# Spartan Fire, LLC

Technical Service Bulletin  
TSB23-260-001

**APPLIES TO:** This service bulletin applies to certain 2008 through 2024 model year, Gladiator, Metro Star, FC-94, KME Predator, KME Panther, Metro Star-RT, Metro Star X and Spartan Force model emergency response chassis cabs built between May 6, 2008 and August 31, 2023.

**Figure 3.1**

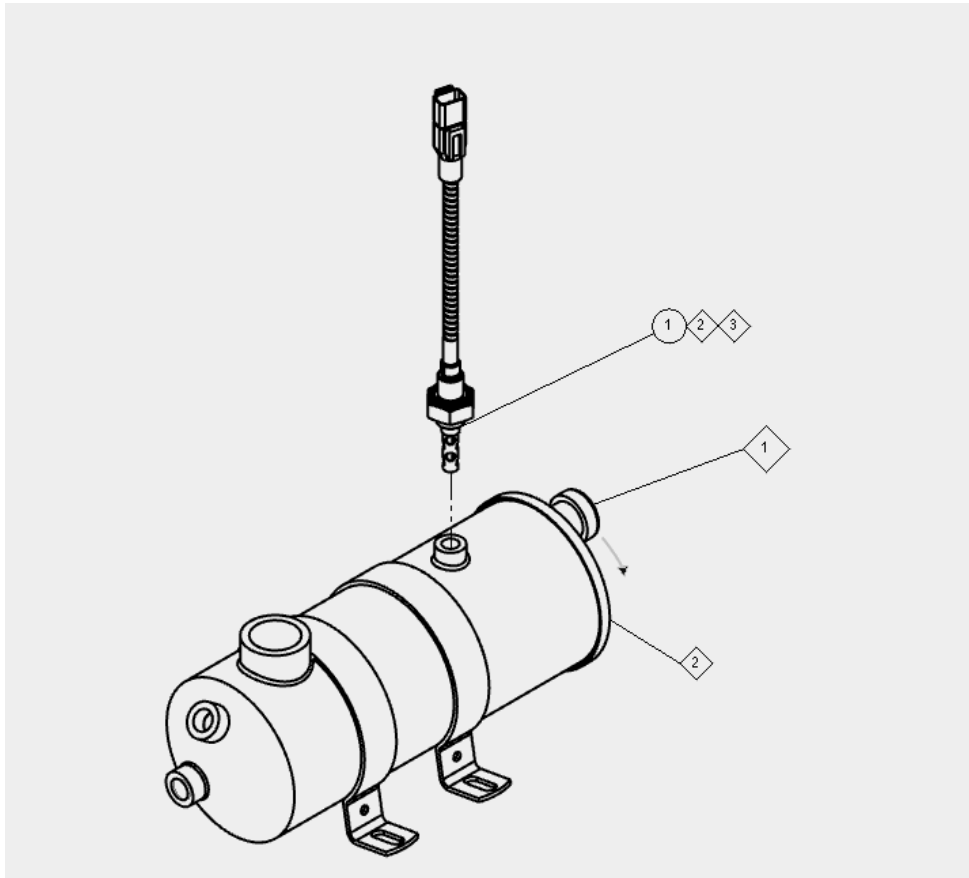
**CONDITION:** Power steering fluid level sensor could exhibit leaks where sensor seals against power steering reservoir.

- 1) Tilt cab following normal operating procedures to access engine compartment.
- 2) Locate power steering reservoir on driver's side of engine.
- 3) Insert drain pan beneath power steering reservoir to collect fluid that will drain out when power steering level sensor is removed.
- 4) Disconnect electrical connector at the power steering level sensor.
- 5) Remove power steering level sensor from reservoir and dispose of. See Figure 2.1 and 3.1

**CORRECTION:** Replace current power steering level sensor with improved design sensor.

- 6) Clean threads where power steering level sensor threads into reservoir bung.
- 7) Ensure new sensor part number 1798-GG3-001 is equipped with the proper o-ring placement.
- 8) Apply 567 Loctite thread sealant to approximately 5 threads in from end of sensor.
- 9) Thread new sensor into boss and tighten to **35 in. lbs.**
- 10) Apply a clocking mark to sensor hex and reservoir housing bung for detection of any loosening in the future.
- 11) Connect new sensor connector to vehicle harness connector.
- 12) Fill power steering reservoir with power steering fluid to full line on dipstick.
- 13) Start engine and run for 1 minute to purge any air from system.
- 14) Recheck level and top off as necessary.
- 15) Lower cab following prescribed procedure for safely lowering cab.
